Addendum No. 2
May 20, 2020

Project: Fitzgerald Stadium Renovations
Rapid City, SD
City Project # 19-2508 / CIP 51231
Architect Project #2692

ADDENDUM No. 2 - STRUCTURAL ITEMS

Foundation Plan - Sheet 3.13

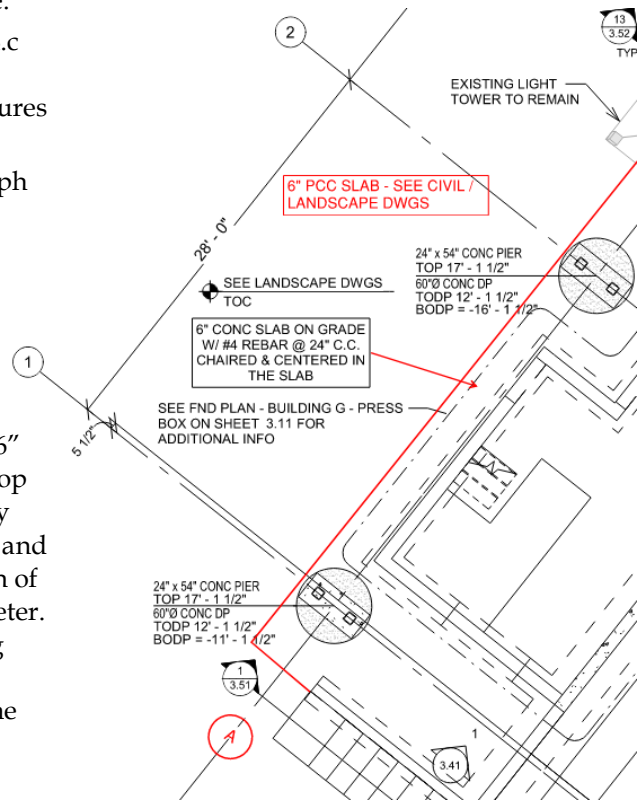
1. Clarification: The limits of the 6" reinforced concrete slab at the top of the stadia seating is bound by the stadia staircases on the east and west ends and is 2'-4 1/8" north of Grid A around the outer perimeter. Slabs thereafter are PCC paving per the civil and landscape drawings. See partial plan to the right.

Enlarged Framing Elevations - Sheet 3.41:

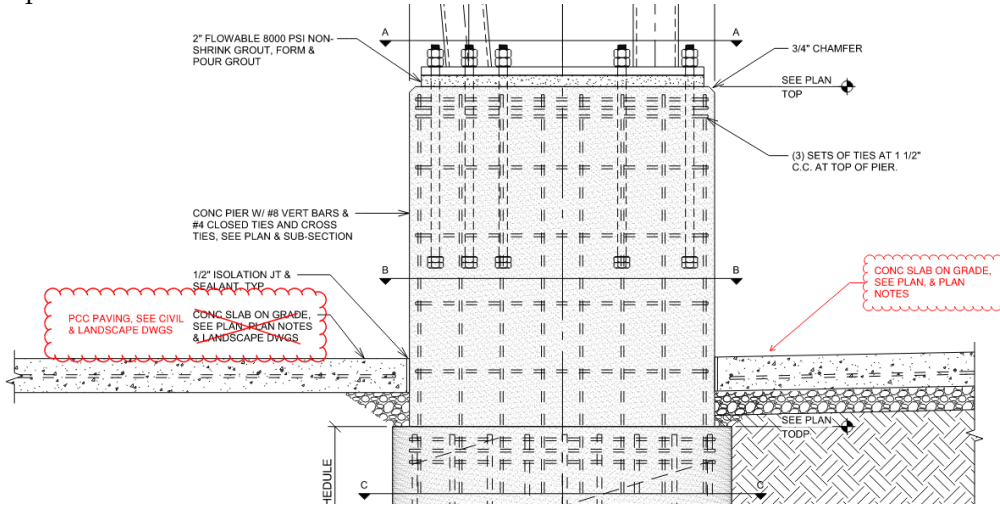
1. Framing Elevation 1/3.41 - Clarification: The 6" reinforced slab referenced in plans is to the right of the concrete pilaster. The paving to the left is PCC paving, see civil and landscape drawings. See partial section below.

Risers & Seating Sections - Sheet 3.51:

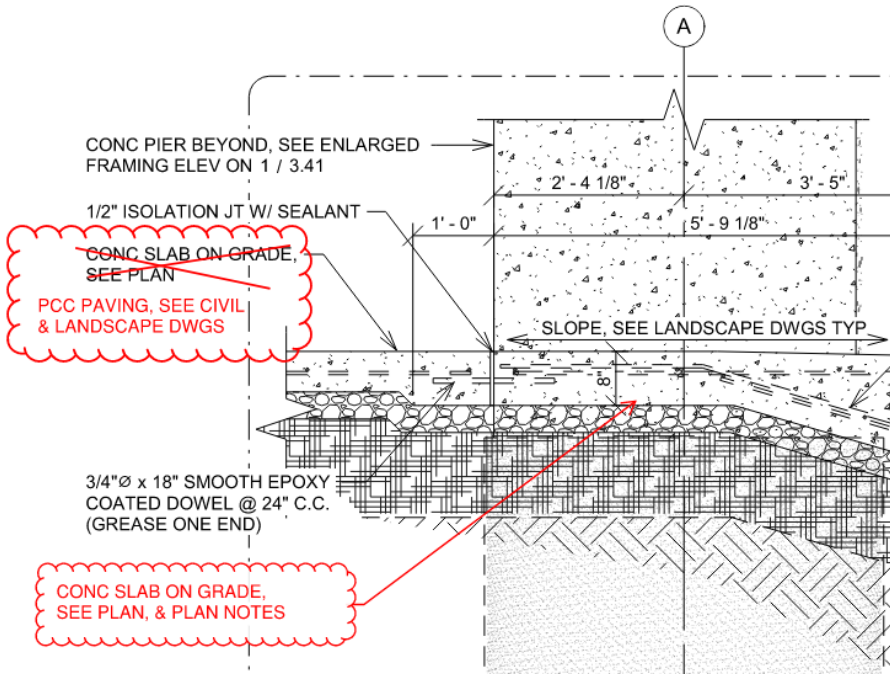
1. Sections 1, 2 & 4 – Clarification: The 6" reinforced slab referenced in plans is to the right of the doweled joint. The paving to the left of the doweled joint is PCC paving, see civil and landscape drawings. See representative typical partial section below.
